FILE NUMBER: Z201-332(KC) **DATE FILED:** August 2, 2021**LOCATION:** Southwest corner of North Riverfront Boulevard and Cole Street.**COUNCIL DISTRICT:** 6 **MAPSCO:** 44 H**SIZE OF REQUEST:** Approx. 1.62 acres **CENSUS TRACT:** 0100.00

REPRESENTATIVE: Jackson Walker LP (Bill Dahlstrom)**APPLICANT:** Bird's Opening, LLC**OWNER:** Ewing Properties, LLC**REQUEST:** An application for 1) a new subdistrict; and 2) a Specific Use Permit for Indoor Athletic and Entertainment Center use on property zoned Subdistrict 1A within Planned Development District No. 621, the Old Trinity and Design District.**SUMMARY:** The purpose of the request is to reduce the required parking and require an SUP for the proposed Indoor Athletic, and Entertainment Center use and for an SUP to allow for the Indoor Athletic and Entertainment Center.**CPC RECOMMENDATION:** **Approval** of the new subdistrict, subject to a revised development plan, a landscape plan, and conditions; and **approval** of the Specific Use Permit for a seven-year period, subject to a revised site plan and revised recommended conditions.**STAFF RECOMMENDATION:** **Approval** of the new subdistrict, subject to a development plan, a land

CPC RECOMMENDED DEVELOPMENT PLAN

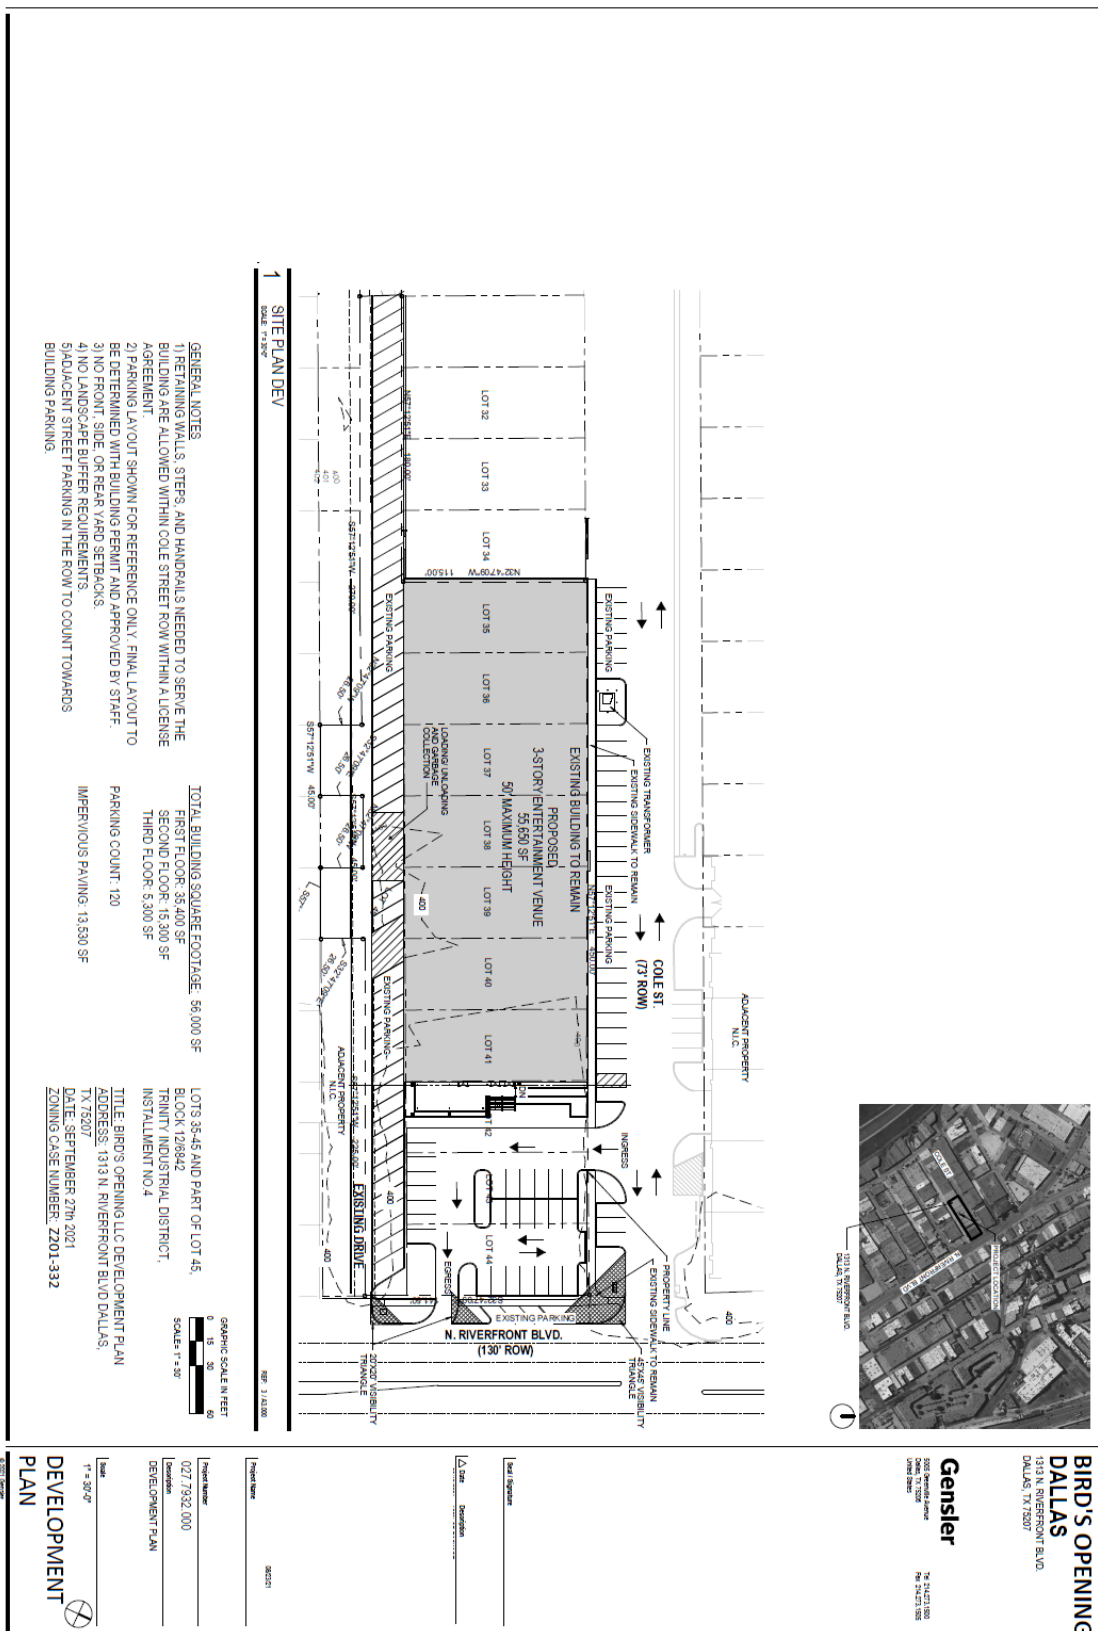
Staff still recommends approval of the proposed development plan and SUP site plan **subject to** the following revisions:

- Plans must comply with ADA sidewalk requirements and provide at least 5-ft wide sidewalks while still accommodating adequate space for 18-ft indented head-in parking along Cole.

The proposed conditions allow for this site to not be subject to the site design standards provided in PD 621. Staff does not support the proposed site plan showing the existing sidewalks that are noncompliant to remain. Staff recommends that the site comply with ADA sidewalk requirements and provide at least 5-ft wide sidewalks while still accommodating adequate space for 18-ft indented head-in parking along Cole Street. In addition to the design standards, the conditions allow for the site to not be subject to the screening requirements. Although it is not subject to the requirements, there is still shrubs and street trees provided on the landscape plan to help screen the off-street parking that is being proposed within the parking lot. The landscape plan is providing trees and shrubs

CPC RECOMMENDED LANDSCAPE PLAN

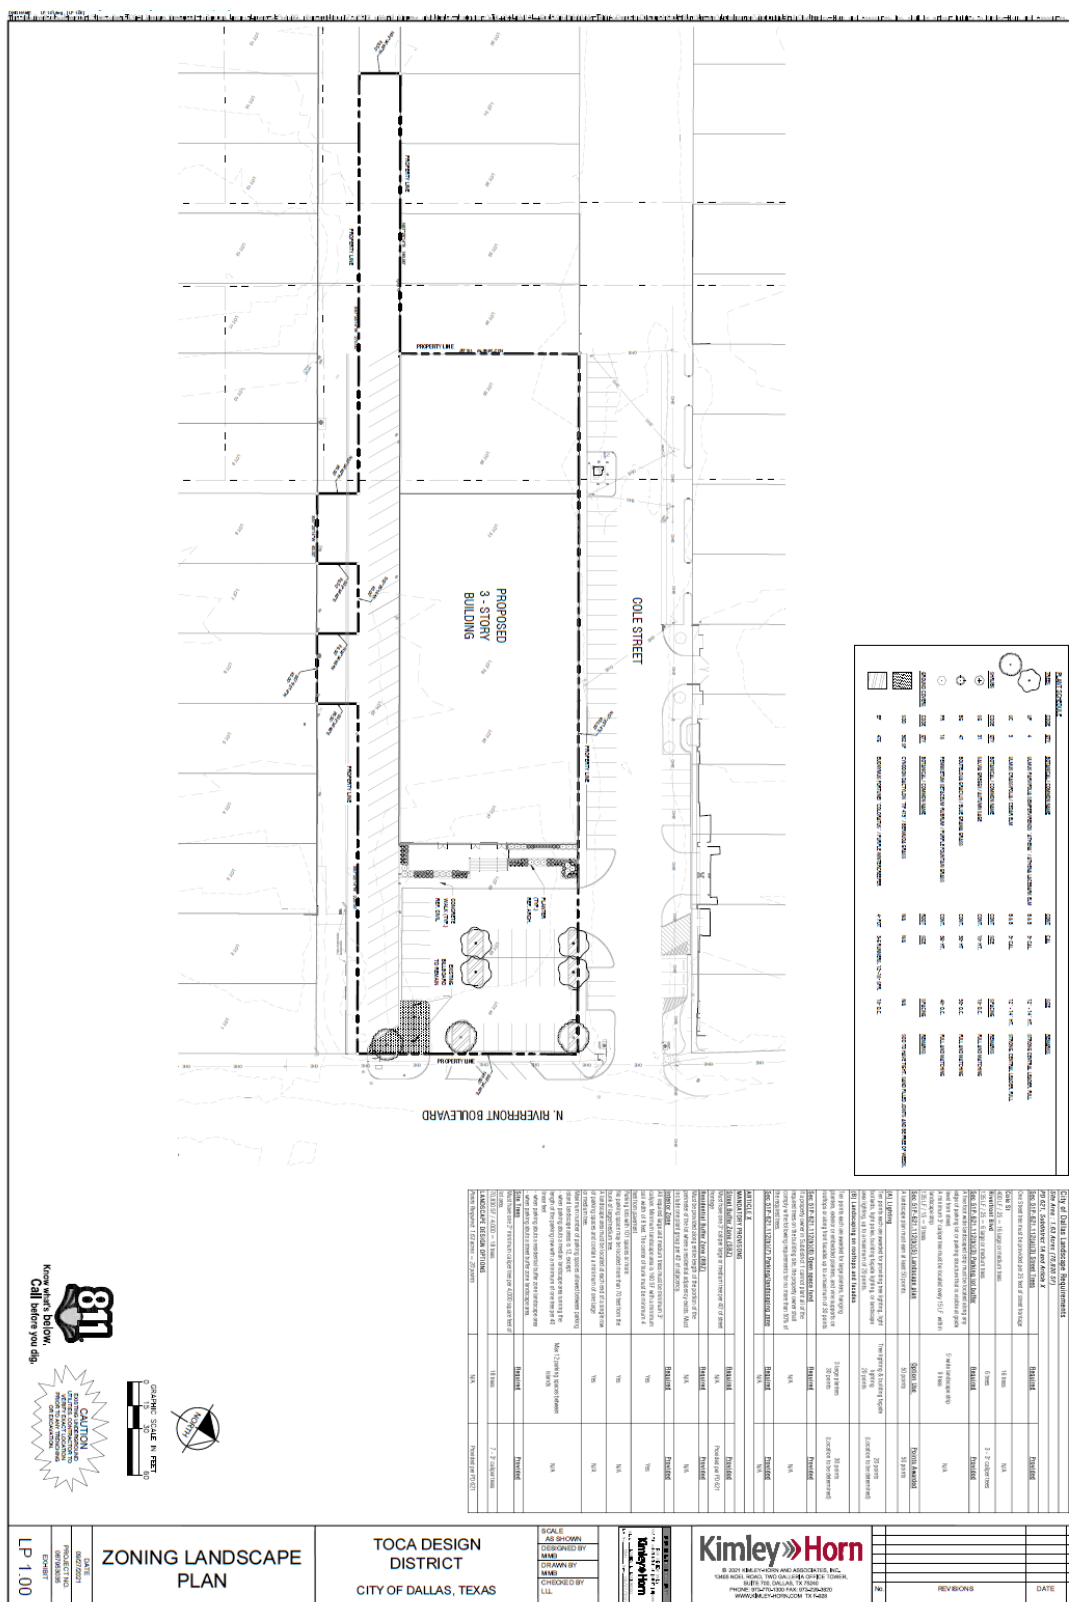
The request includes amending the landscaping requirements to deviate from what is required per the current PD 621 conditions. The landscape plan shows a total of seven trees provided, as opposed to the 18 required. In addition, Cole Street requires 16 street trees along the frontage and Riverfront Boulevard requires six but only two street trees along Cole Street and three street trees along Riverfront Boulevard are provided.

CPC RECOMMENDED SITE PLAN

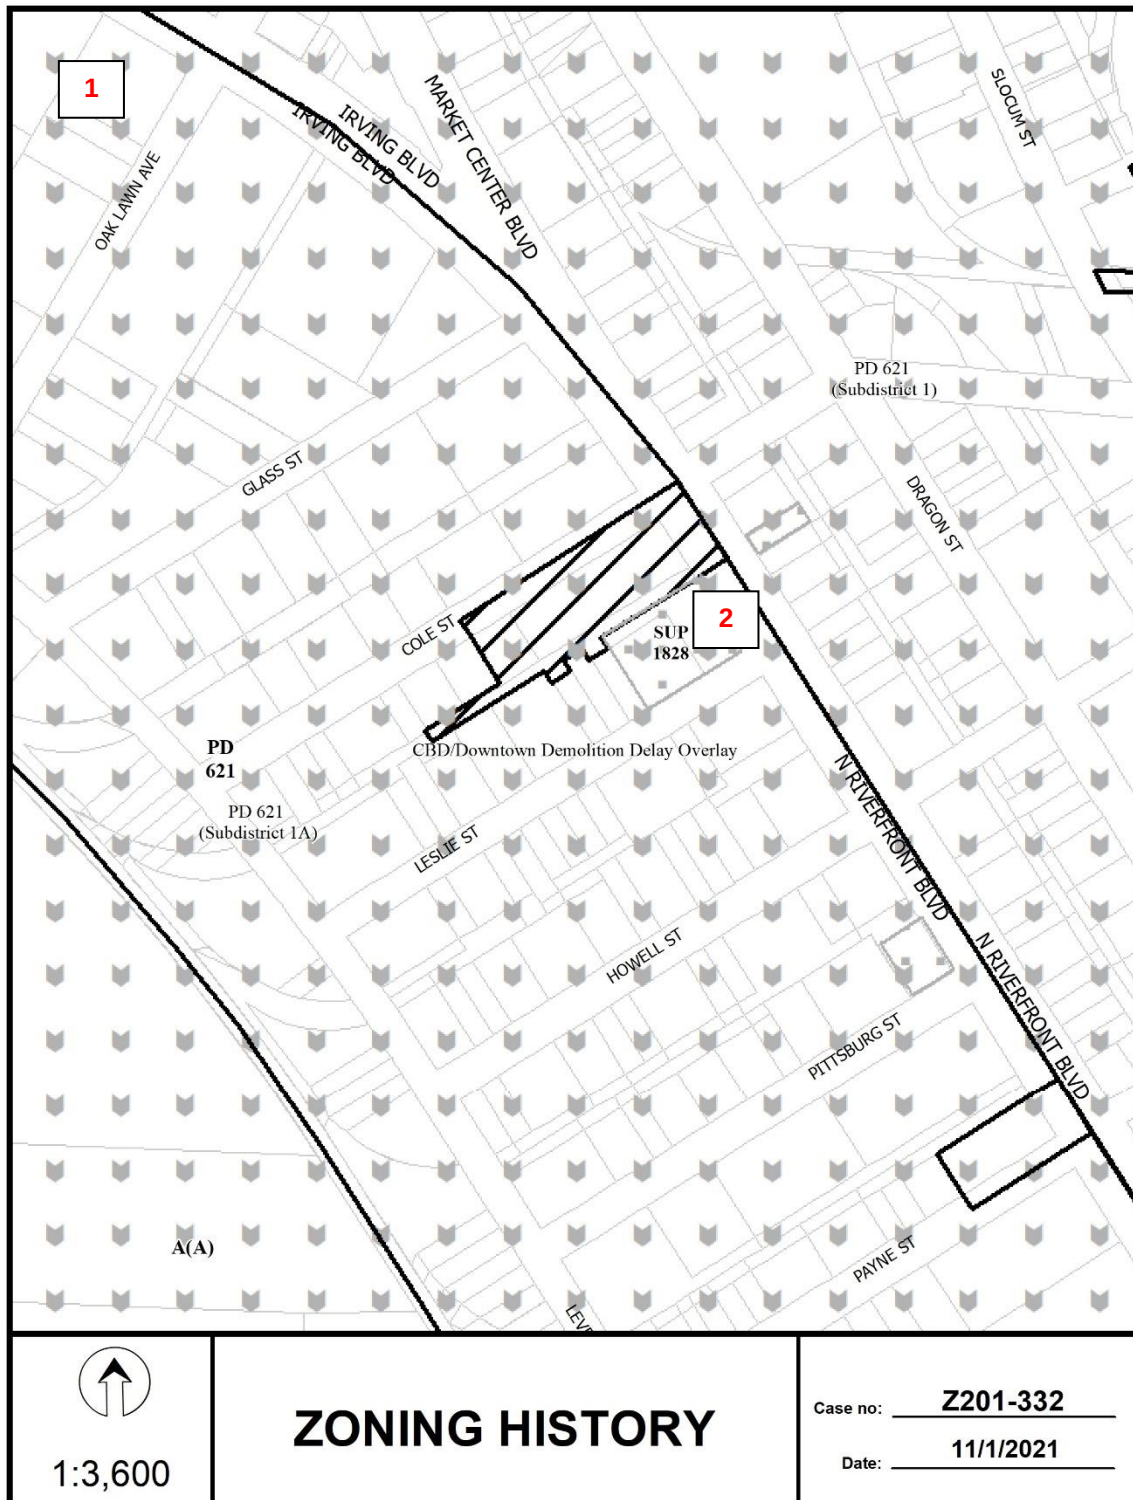
The applicant is requesting reduced parking requirements within the proposed subdistrict. The off-street parking requirement for a commercial amusement (inside) use may be established in the ordinance granting the SUP, otherwise one space per 100 square feet of floor area is required, which would require a total of 557 spaces. Although the site includes 55,650 square feet of a commercial amusement use, there will be three full sized soccer fields within the structure. The full occupation of the site would allow for 408 guests. According to the parking demand study that was provided by the applicant, there are alternative methods of transportation that would allow for guests to arrive or be dropped off, including nearby transit stops. In addition, the site is located near other businesses that close during the peak hours of this use and would allow for shared parking. On street parking is also taken into consideration within PD 621. The study identifies that 117 parking spaces is what is needed to efficiently park the proposed use. A total of 120 parking spaces are shown on the site plan. However, the parking ratio
